JINDAL ALUMINIUM LTD.
BANGALORE-560073 (INDIA)

NAME	DATE
DRAWN	PRASANN.H	16-01-2008
CHECKED		
APPROVED		
SCALE		1:1
AREA mm ²		1603.708
PERIMETER mm.		1116.403
WEIGHT kg/m		4.330 ②
DRAWING No.	SECTION No.	
P-7751-1	-	
27241	27241-ISSUE-2

PARTY'S NAME	GENERAL CATEGORY, COIMBATORE MARKET
PARTY'S DRAWING No.	46-03-06
ALLOY & TEMPER	HE9 WP
DESCRIPTION	PUMP BODY

P-7751-1

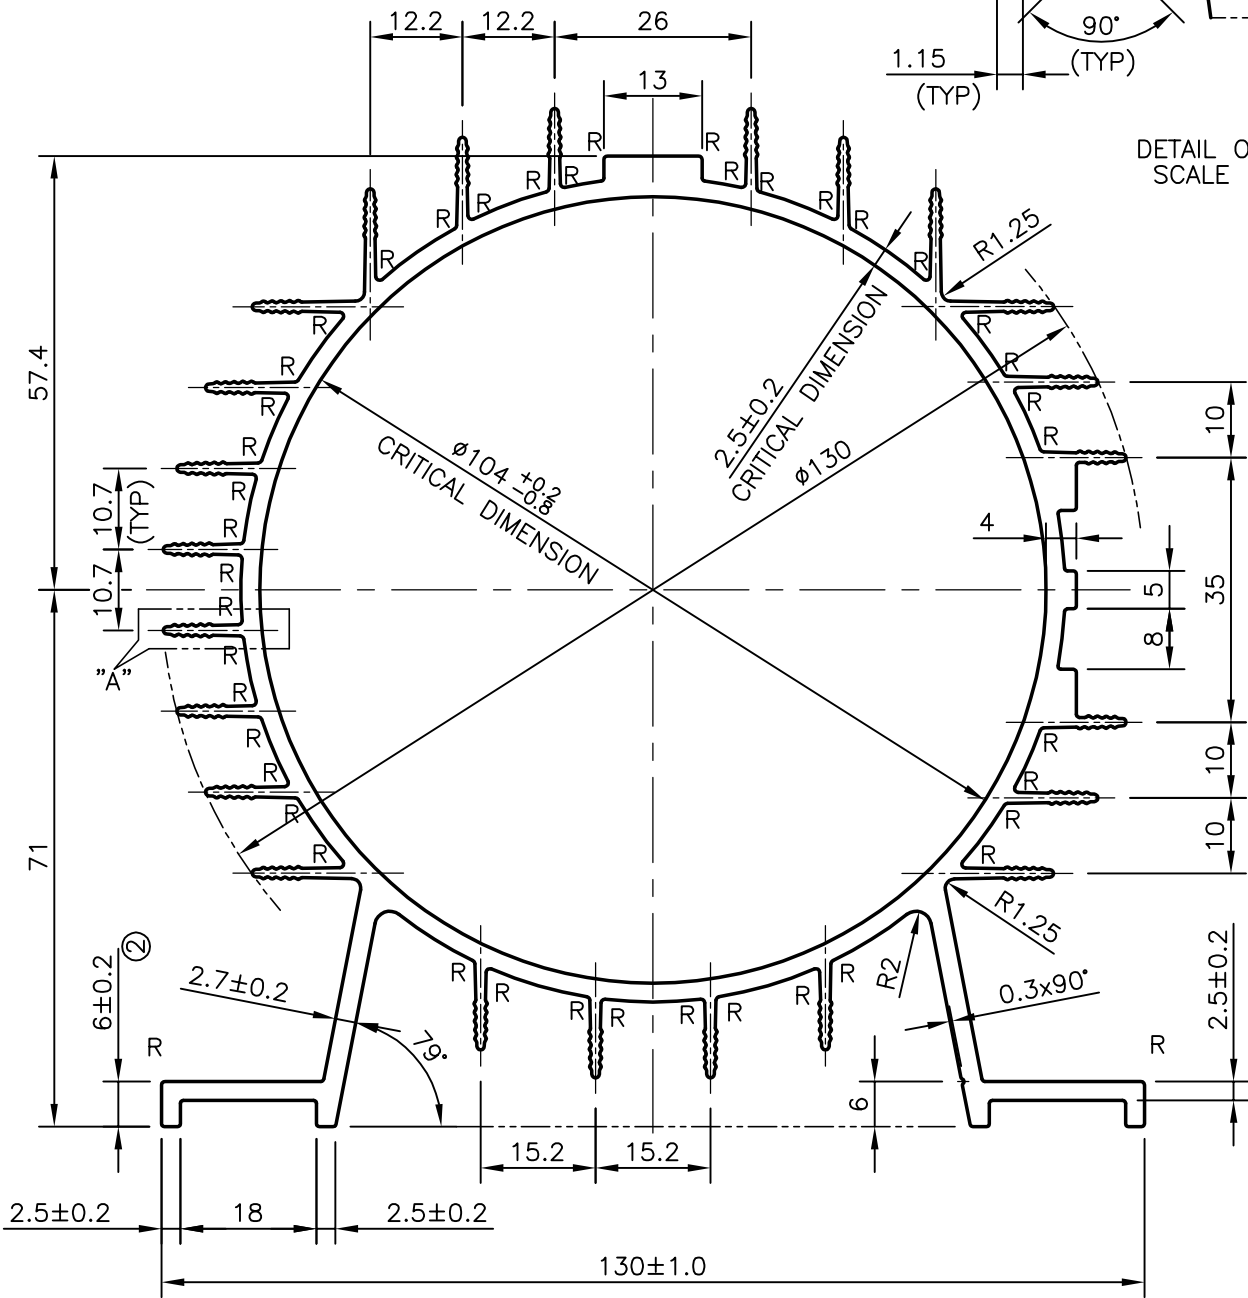
ISSUE- ②

DIMENSION CHANGED FROM 8.0 mm TO 6 ± 0.2 mm

AND WEIGHT ALSO CHANGED FROM 4.369 kg/m TO 4.330 kg/m, AS PER CUSTOMER REQUIREMENT
